**Customer Intermittently Locked Out Of  
Vehicle After Closing Door –  
Install New Door Handle Damper**

MODEL 2001 MY-ON  
S-TYPE  
VIN M23023-ON

ILLUSTRATION 1

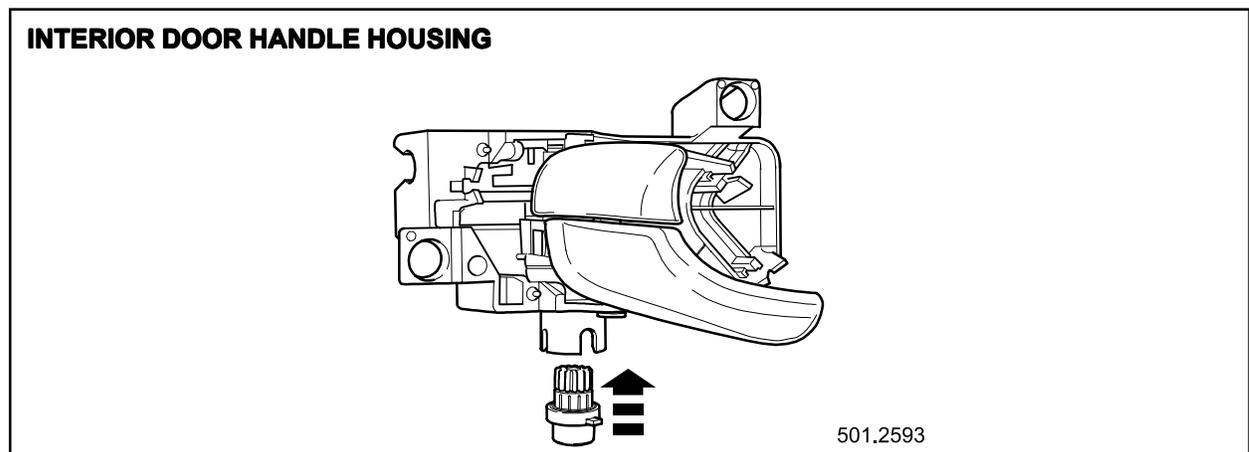
Some 2001 MY-ON S-TYPE vehicles, customers may have a concern of intermittently being locked out of the vehicle after closing a front door.

This problem may be caused by the interior handle springing back and activating the central locking. To address this concern, a new damper can be installed to both front interior door handles.

2. Install and fully seat the new damper into the interior door handle housing, ensure damper is located with a definite click (Illustration 1).
3. Install left hand front door trim panel (see Workshop Manual, JTIS CD ROM, section: 501-05, SRO 76.34.01).
4. Carry out steps 1 to 3 for the right hand side.
